Docket Item #8
BAR CASE #2004-0277

BAR Meeting
January 26, 2005

ISSUE: Re-approval of alterations

LOCATION: 330 North Patrick Street

Figure 1 - Front and North Elevation

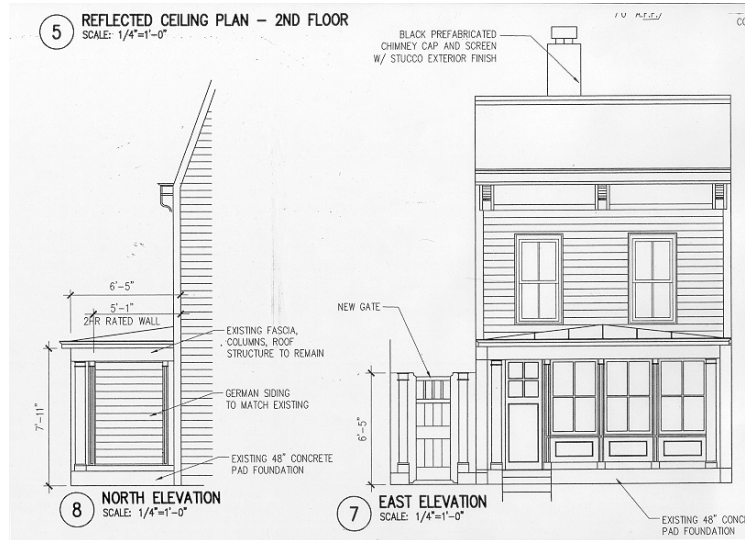
The applicant is proposing to enclose the existing front porch. The porch will become an enclosed room and access to the house from the front will be eliminated. The door on the enclosed porch is for appearance only and will not be operable. The porch enclosure will retain the existing porch in its entirety, except for the railing. Walls with fixed windows on the south and east sides and covered in German siding on the north side, will be built just behind the porch columns to enclose the porch. The windows, will be Pella Architect Series, wood, true divided light, with low "E" glass. The front (east) elevation will have three windows with panels below. In the prior approvals, the Board specified that these panels should be wood boards, rather than MDO or some other manufactured material. The applicant has confirmed that they will be wood boards. At the south end of the front elevation, there will be a door with four lights at the top.

The applicant has confirmed that the door will be wood. The south elevation will have a single two-over-two window with panel below. In the two prior submissions, this elevation had a longer window and no panel below. According to the applicant, the porch roof, which is presently clad in asphalt, will be covered in standing seam metal.

Staff continues to oppose the porch enclosure. A review of the minutes of previous hearings indicates that the Board assumed that the applicant would, at least for the present, leave the original front wall of the house intact behind the enclosure. The present design of the enclosure, incorporating as much window area as possible, evolved in response to the Board's expressed desire to maintain a sense of openness and a view of the full front of the house. The current interior drawings show that the front of the house will be virtually eliminated on the first floor. Thus, the enclosure is, in effect, an addition to the front of the house. The addition significantly alters the historic character and appearance of what is today an intact example of a vernacular 2nd Empire house type favored in Alexandria from the late 19th century through the 20th century. This type was most often constructed with a flat front. Sometimes, single story *open* porches

were added to the front, generally in the first two decades of the 20th century. Somewhat later in the 20th century, an enclosed porch or sunroom like that proposed might have been added to an existing house, but more typically at the rear or side, rather than in the front. To summarize, Staff believes the front addition is not compatible with the period and style of the house or the history of residential construction in Alexandria's historic districts and therefore is contrary to the directive in the Design Guidelines that "[t]he design of an addition should respect the heritage of the historic building to which it is attached as well as adjacent buildings" (Residential Additions - Page 5).

Staff recommends that the porch enclosure be denied and that the front fence, HVAC unit, side gateway, chimney and south elevation vents and lights be approved with the following conditions:

Figure 2 - South Elevation

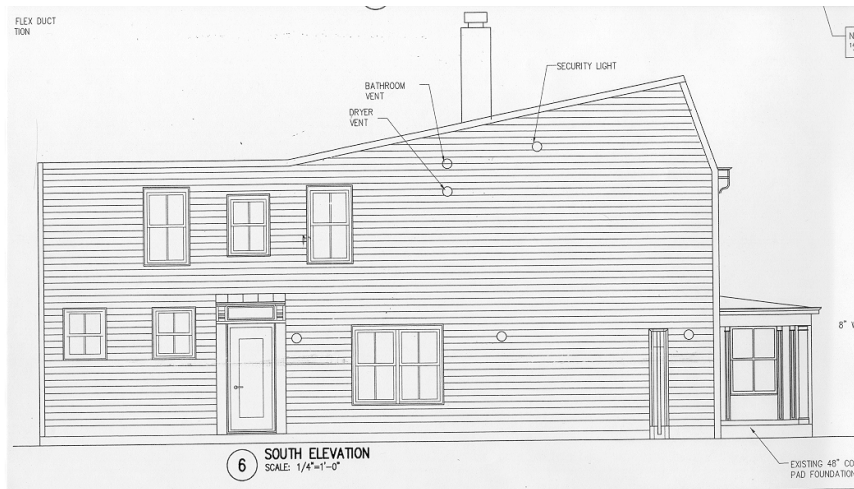
Several new exterior lights and a dryer vent and bathroom vent will be added to the south side of the house.

The vents are an unfortunate necessity. Little can be done except to select those with the smallest possible exterior component and to paint that to match the siding. Staff recommends the security light be as unobtrusive a design as possible and requests an opportunity to review and approve any fixtures that will be visible from the public right of way prior to installation.

1. That the front fence and side gateway be stained or painted after construction;
2. That the vents be painted to match the siding; and,
3. That Staff be provided an opportunity to review and approve the exterior light fixtures prior to installation.
